PARADISE GARDENS SUBDIVISION

Engineering Comments: FINAL PLAT COMMENTS (should be addressed prior to submitting the FINAL PLAT for review and/or signature by the City Engineer):

APPLICATION NUMBER 4 DATE September 5, 2019
APPLICANT Paradise Gardens Subdivision
REQUEST Subdivision

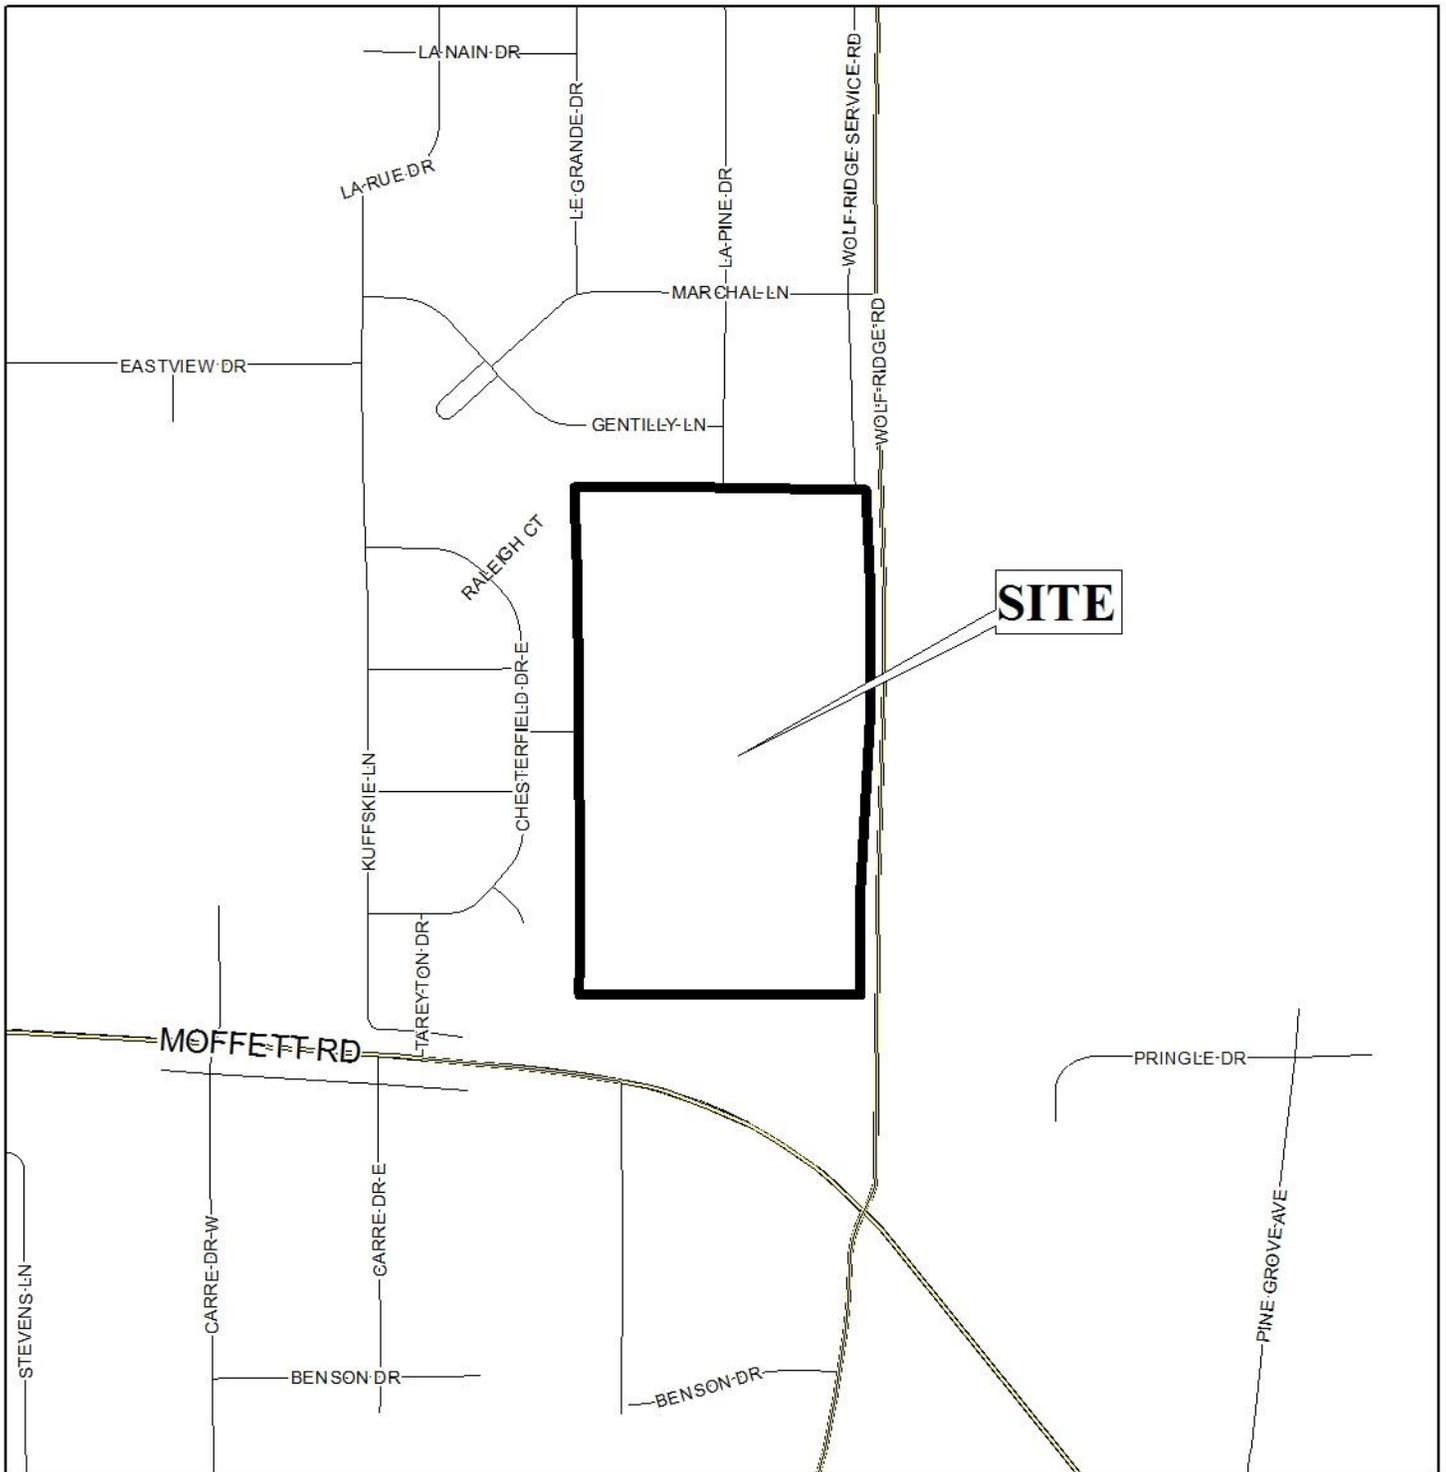
The proposed lot fronts Wolf Ridge Road, along the portion of Inner Ring Road on the Major Street Plan which calls for 100-foot right-of-way dedication. Dedication to provide 50' from centerline should be illustrated on the Final Plat. The preliminary plat illustrates a varying right-of-way width. However, dedication to provide 50' from the centerline is shown, and if approved, the dedication should be retained on the Final Plat.

A 25-foot minimum building setback is required along Wolf Ridge Road however; it is not illustrated on the preliminary plat. If approved, the Final Plat should be revised to reflect the required building setback, from the required dedication.

The proposed lot exceeds the 7,200 square foot minimum lot size requirement for lots served by public water and sanitary sewer systems. The preliminary plat provides the lot sizes in square feet and acres. If approved, the lot size information should be retained on the Final Plat.

- 1) Labeling of existing right-of-way of Wolf Ridge Road and retention of the 50' dedication from the centerline of Wolf Ridge Road;
- 2) Provision of a 25' minimum building setback line along Wolf Ridge Road from the dedication;
- 3) Retention of lot size information in both square feet and acres;
- 4) Placement of a note on the Final Plat stating the following Traffic Engineering comments: (*"Site is limited to the number of driveways on the approved Planning Approval and/or PUD site plan, with any changes in number, size, location and design to be approved by Traffic Engineering and conform to AASHTO standards. Any new on-site"*)
